Form 3160-5
(June 2019)UNITED STATES
DEPARTMENT OF THE INTERIOR
BUREAU OF LAND MANAGEMENTFORM APPROVED
OMB No. 1004-0137
Expires: October 31, 2021**SUNDRY NOTICES AND REPORTS ON WELLS**
Do not use this form for proposals to drill or to re-enter an abandoned well. Use Form 3160-3 (APD) for such proposals.

8. Well Name and No. DILLON 31 FED COM/502H

EOG respectfully requests an amendment to our approved APD for this well to reflect the following changes:

**Dillon 31 Fed Com 502H****Revised Permit Information 07/18/2022:**

WELL LOCATION AND ACREAGE DEDICATION PLAT

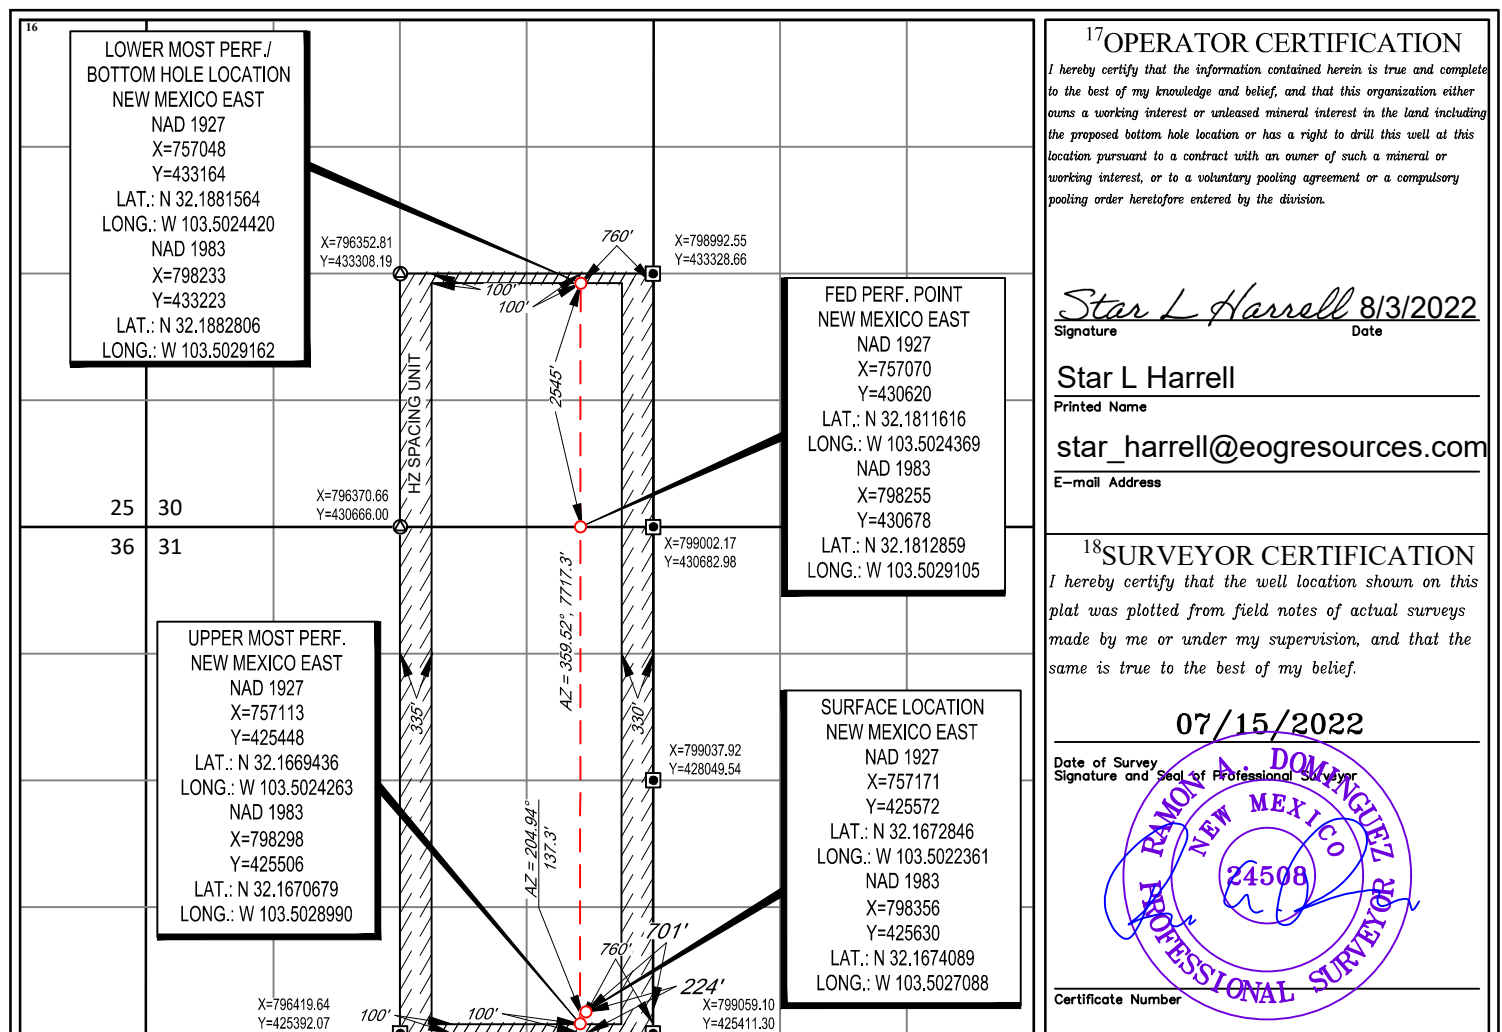
Change BHL from T-24-S, R-34-E, Sec 30, 2544' FSL, 990' FEL, Lea Co., NM,
to T-24-S, R-34-E, Sec 30, 2544' FSL, 760' FEL, Lea Co., N.M.

UL or lot no.	Section	Township	Range	Lot Idn	Feet from the	North/South line	Feet from the	East/West line	County
I	30	24-S	34-E	-	2545'	SOUTH	760'	EAST	LEA
